**Distribution of Textron Lycoming
Service Bulletin 529A, "Reprint of
Crane/Lear Romec Service Bulletin No.
101SB020, Rev.2"**

Service Bulletin No. 529A
 (Supersedes Service Bulletin No. 529)
 Engineering Aspects are
 FAA Approved

SUBJECT: Reprint of Crane/Lear Romec Service Bulletin No. 101SB020, Rev. 2

FUEL PUMP – Torquing of Relief Valve Cover Screws.

Torquing Sequence – RG17980 Series
Figure 1

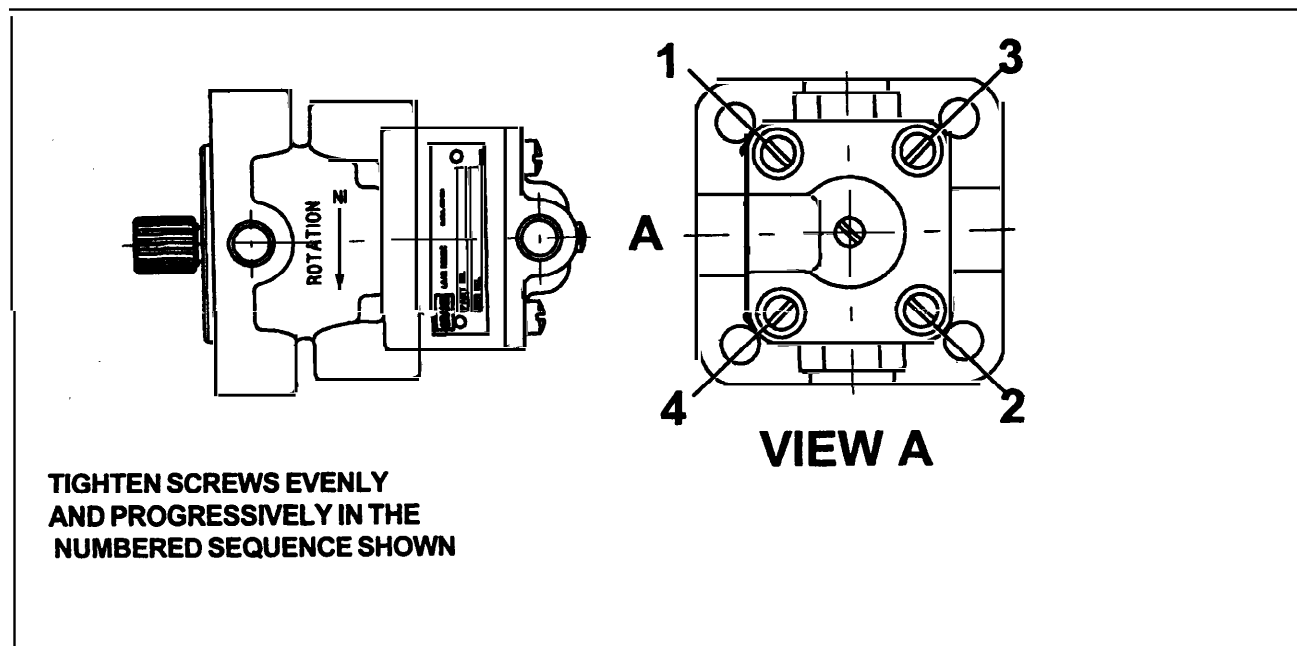
- (a) If pump is accessible without removing it from aircraft, the following check shall be performed.
- (b) Visually inspect the split line between the pump housing and relief valve housing for any evidence of noticeable gasket extrusion adjacent to the pump inlet & outlet ports. If there is evidence of noticeable extrusion, replace the pump per applicable engine maintenance instructions.
- (c) Check the tightness of relief valve cap attaching screws using a torque indicating screwdriver. Minimum torque shall be 23 inch-pounds. Torque shall be checked in the tightening direction.
- (d) If screws are loose, remove safety-wire and tighten screws evenly and progressively in a criss cross pattern to 23-25 inch-pounds torque in the sequence shown in figures 1 and 2.

- (a) Visually inspect the split line between the pump housing and relief valve housing for any evidence of noticeable gasket extrusion adjacent to the pump inlet & outlet ports. If there is evidence of noticeable extrusion, replace the pump per applicable engine maintenance instructions.
- (b) Check the tightness of relief valve cap attaching screws using a torque indicating screwdriver. Minimum torque shall be 23 inch-pounds. Torque shall be checked in the tightening direction.
- (c) If screws are loose, tighten screws evenly and progressively in a criss cross pattern to 23-25 inch-pounds torque in the sequence shown in figure 1 and 2.

NOTE: If screw torque registers greater than 23-25 inch-pounds when inspected per para. 2.A.(1)(c) above, the screws need not be backed off and retorqued. This bulletin applies only if screws exhibit preload torque of less than 23 inch-pounds.

NOTE: If screw torque registers greater than 23-25 inch-pounds when inspected per para. 2.A.(2)(b) above, the screws need not be backed off and retorqued. This bulletin applies only if screws exhibit preload torque of less than 23 inch-pounds.
